JUSTIFICATION
BAKE HOUSE RECONSTRUCTION

The drawings below serve as a comparison between the original bake house rear elevation, the approved scheme and the re-constructed building.

BAKE HOUSE - PARAPET AND SECRET GUTTER

CORKSCREW WINDER STAIRCASE

2. Proposed ground floor plan

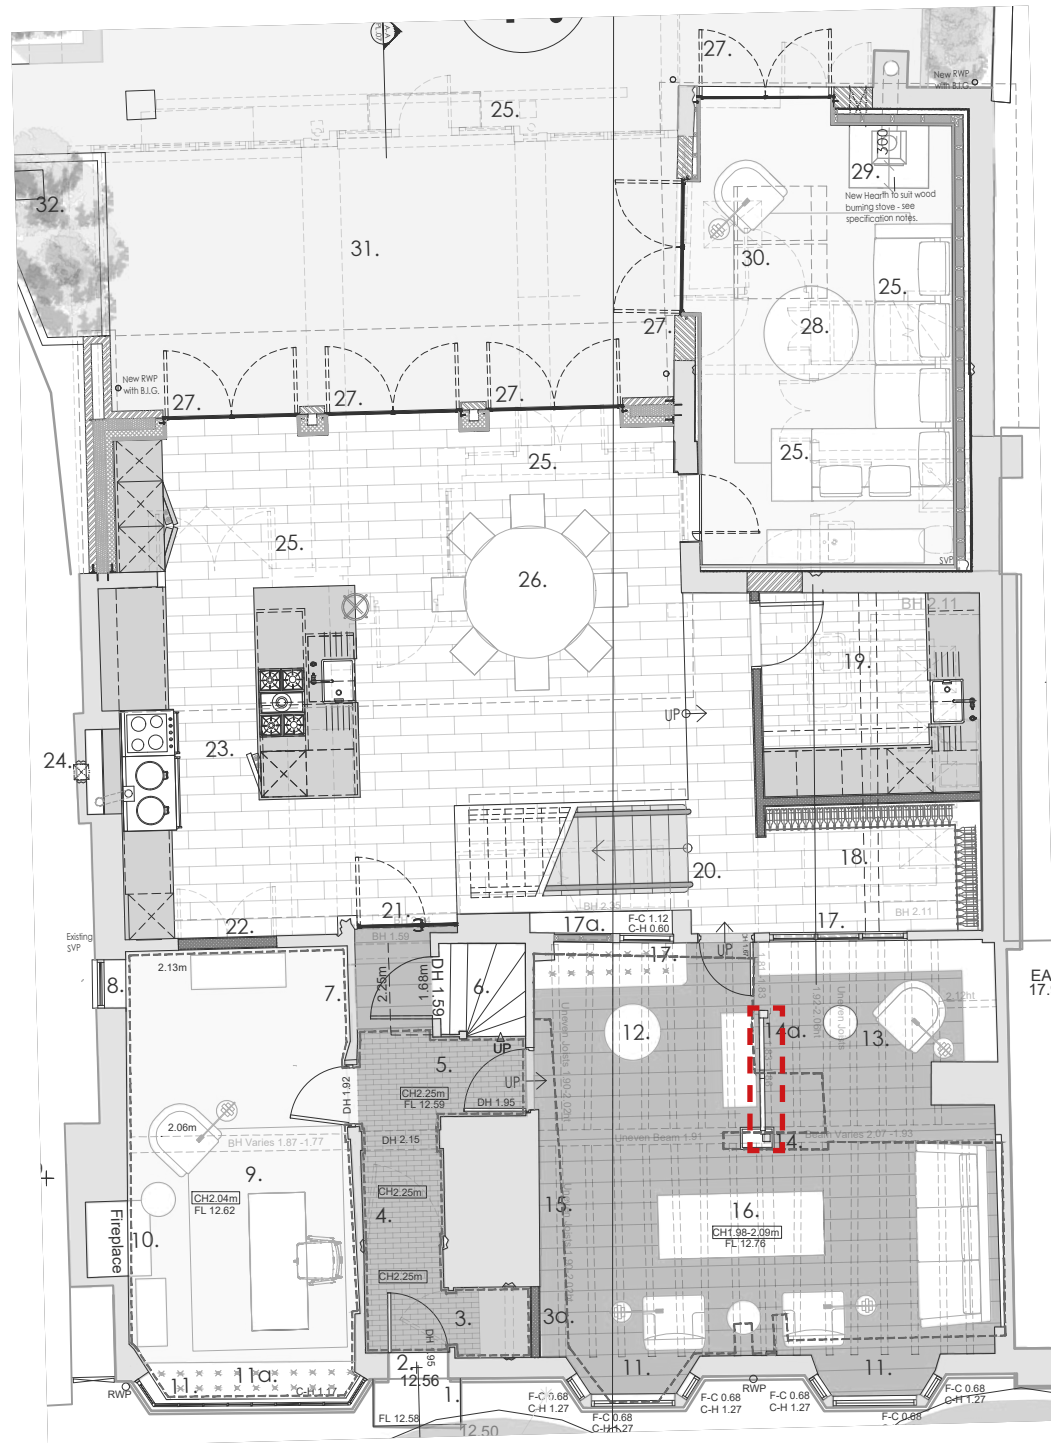
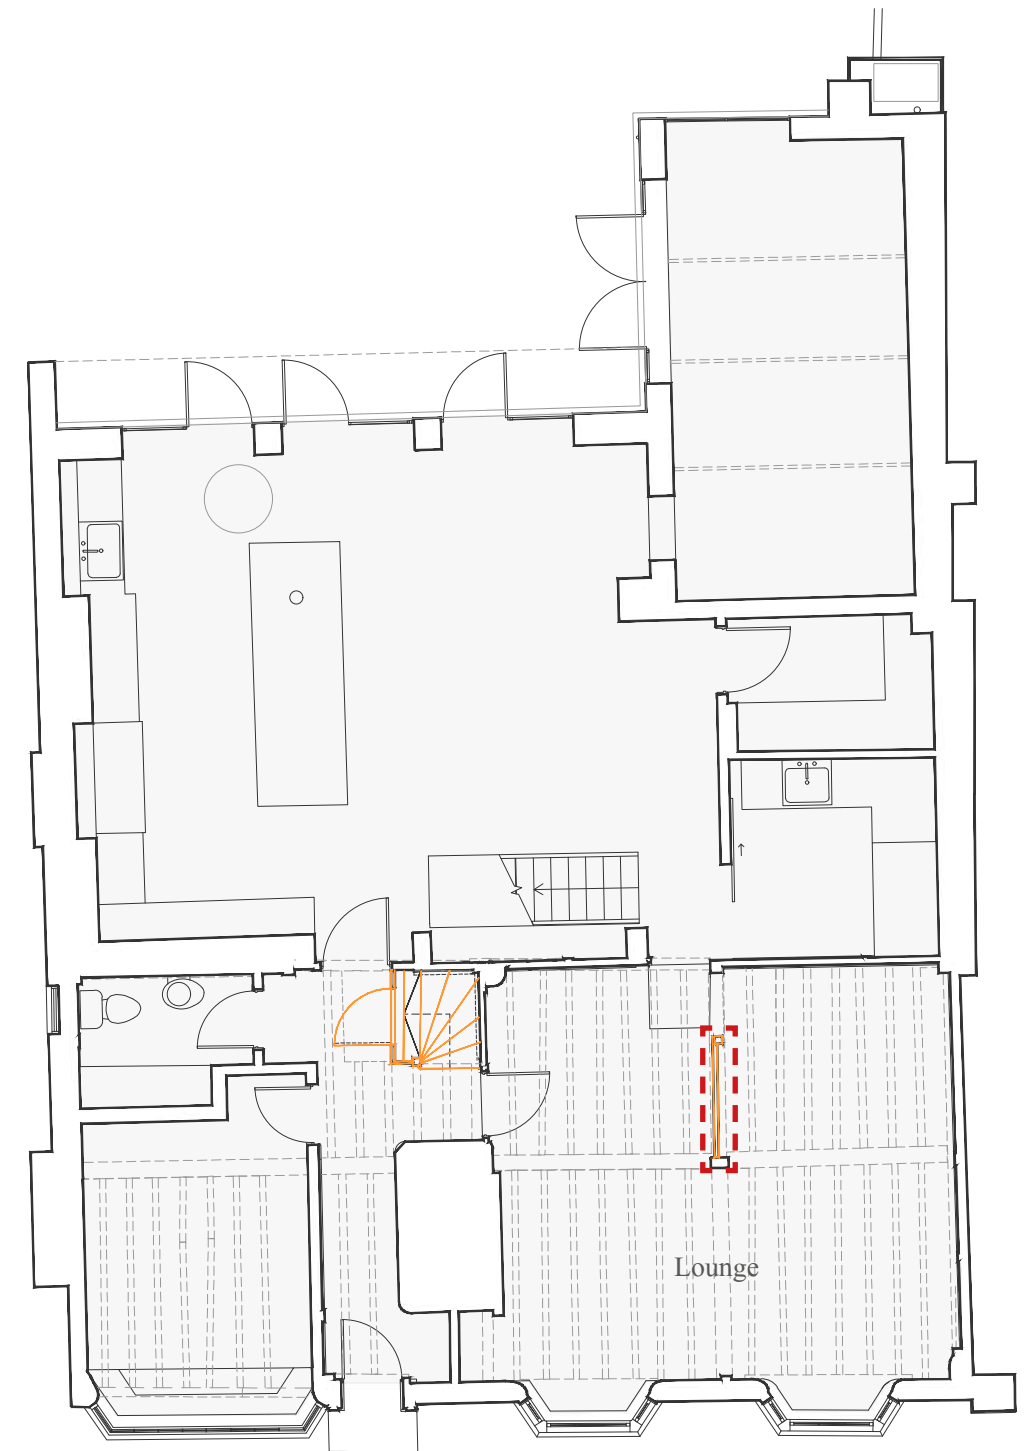
A small section of wall, found to have modern infill, but with references to a historic door opening was removed from the lounge. Whilst the removal of the modern materials is a helpful step in retaining the character of the property, the owner is willing to install a new high quality hand carved oak post, to be dowelled into the original oak frame in the position of the doorway in question, and associated horizontal timber member. Please refer to the following page for detailed justification.

- The existing timber beam and part of timber frame on western wall retained
- Modern infill panels removed (approved and implemented)
- Steel column removed, replaced with the new oak post (approved, heritage benefit) - due to its size, the gun stock post encroached onto the existing wall. To allow for the structural works of the new gun stock post a short section of the partition wall had to be removed.
- Small remaining section of poor quality existing timber frame / door jamb removed, facilitating a plan form more conducive to modern living.
- Central timber element - discovered to be a decorative timber fillet element, not forming part of wall frame. Removed together with infill panels.
